CUT PATTERN	
BACK FRAME NO.	
BASE FRAME NO.	
WOOD PATTERN

*ARM FRAME DETAIL (SIDE VIEW)

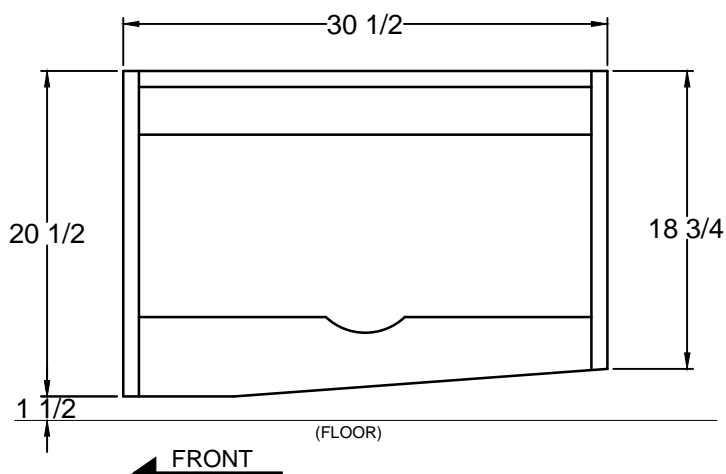
- CONNECT SEAT WRAP TO FOOTREST PANEL.
(REF. ECO #059-2019)
- ADD BLACK DECKING SKIRT INSIDE FOOTREST.

JA	D	ADD NOTES TO CONNECT WRAP TO FOOTREST PANEL, AND ADD BLACK DECKING SKIRT TO INSIDE FOOTREST. (REF. ECO #059-2019)	02.24.2020
JA	C	[1] ADD SPRING CLIPS TO SEAT SPRINGS, [2] ADD 8x24 602 SPRINGS x4, [3] ADD 4-1/2" FOAM TO UPPER BACK & 3-1/2" FOAM TO LOWER BACK, (REF. ECO #029-2019), [4] MECHANISM LEG A410812333S 23" WIDE MECH W/SWIVEL 4108-2, (REF. ECO #059-2019)	06.10.19
JA	B	PRODUCTION UPDATE: [1] ADD ARM FRAME DETAIL, [2] CHANGE ARM FRAME WIDTH TO 2-1/4", WAS 2", [3] CHANGE ARM HEIGHT TO 24-1/2", WAS 27", [4] CHANGE WIDTH TO 29", WAS 28-1/2", [5] CHANGE DEPTH TO 34-1/2", WAS 36-1/2", [6] CHANGE FRAME HEIGHT TO 36", WAS 35-1/2", [7] CHANGE O.A. HEIGHT TO 37-1/2", WAS 38", [8] ADD 20" SEAT DEPTH, [9] ADD 4-1/2" SEAT FOAM	01.28.19
JA	A	PER RL, O.A. HEIGHT IS 38", WAS 40-1/2".	11.08.18
